Wisconsin Department of Transportation

**Proposal #40: 7730-20-60
 Cream - Mondovi
 CTH U to STH 37
 STH 88
 Buffalo County**

This is Addendum No. 01, which provides for the following:

ADDENDUM NO. 01

WisDOT Longitudinal Joint – Nuclear Gauge Density Layout

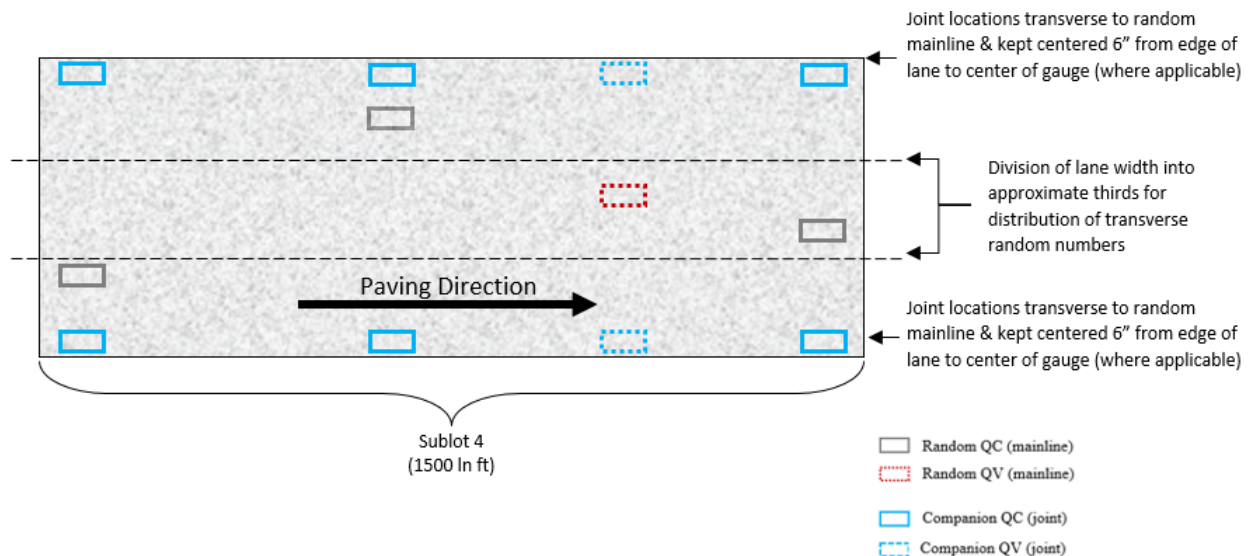
Each QC and QV density location must have a companion density location at any applicable joint. This companion location must share longitudinal stationing with each QC or QV density location, and be located transversely with the center of the gauge 6-inches from the edge of the paving area.

For QMP HMA Pavement Nuclear Density projects, this appears as follows:
